Alabama State Port Authority
Addendum to R&P or Specification Booklet

Project Name Pit and Roof Extension TASD Diesel Shop

Project No. 11407 **Task No.** 02 **Addendum No.** 2

The following items are clarifications to questions received. These items are hereby included in the bid documents by this addendum.

22x34 REV.

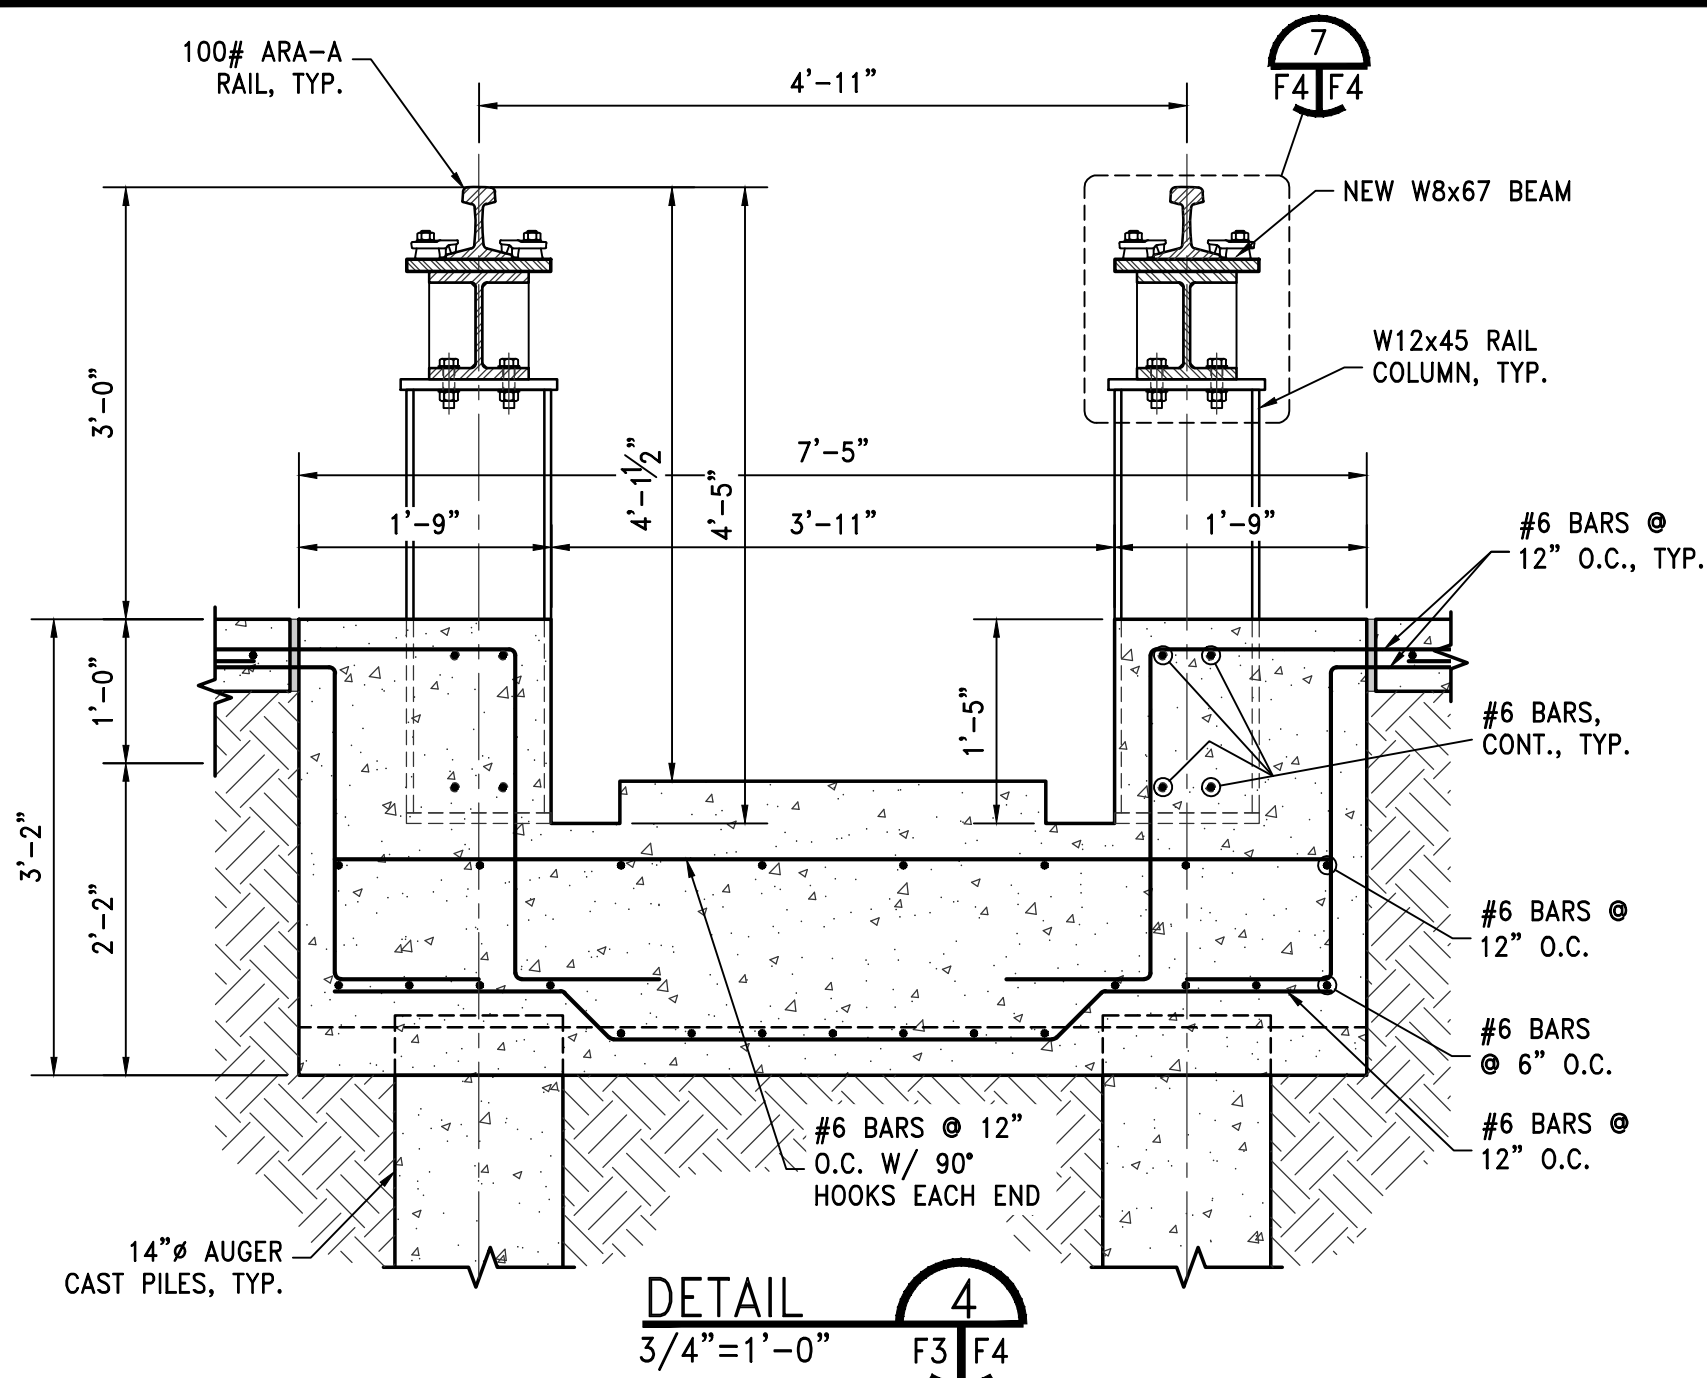
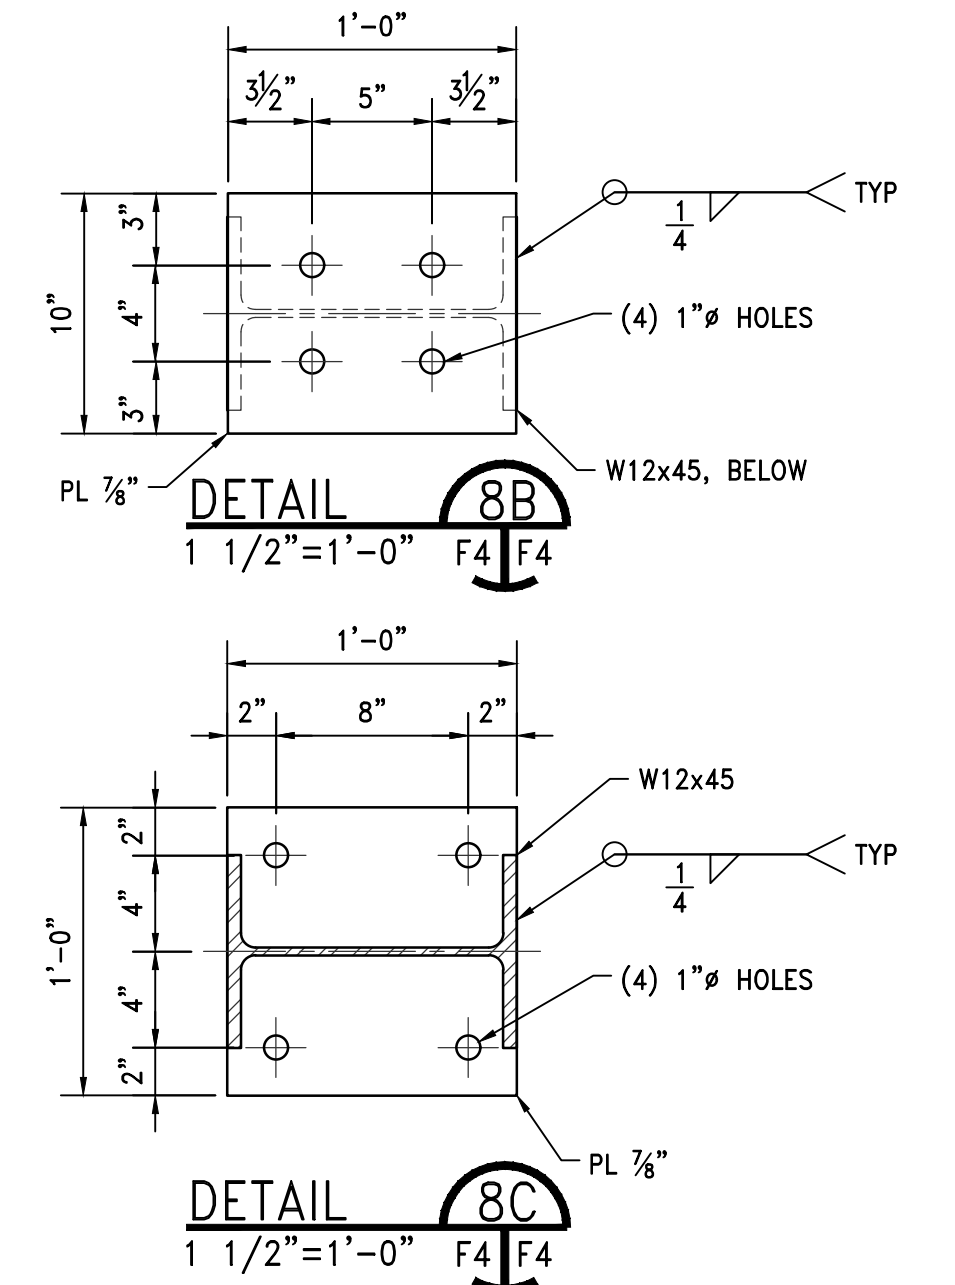
5.	<p>Question: Can you confirm that there are no 16" piles on the project? The pile details show both 14" and 24" piles, but there is one callout for 16" in drawing 4503-F4 detail 5A.</p> <p>Answer: There are no 16" piles on the project. Only 14" and 24". See revised 4503-F4.</p>

10.	<p>Question: Could you please provide a Geotech report?</p> <p>Answer: Yes, the Geotech report will be provided to all prospective bidders.</p>
11.	<p>Question: The Enlarged Foundation Plan of the pit area as shown on drawing 4503 – F3 seems to show (8) pilings having a larger diameter than 14" as scaled on Detail G/F4. These piling scale 16" diameter, however there is no detail for a 16" diameter auger cast pile. Detail 5A/F4 calls for a 16" diameter pile at the location shown on detail F/F3 as a 14" Diameter pile. Section E/F3 identifies (4) piles as 14" diameter at the location shown on detail A/F4 as 24" diameter piles. Please clarify.</p> <p>Answer: There are no 16" augercast piles. The larger piles called out as 14" on 4503 – F3 should be 24" diameter -See addendum 1, revised 4503-F3. On Section E, the piles supporting a cap with a 4'-0" pedestal are 24" diameter. See revised 4503-F4.</p>
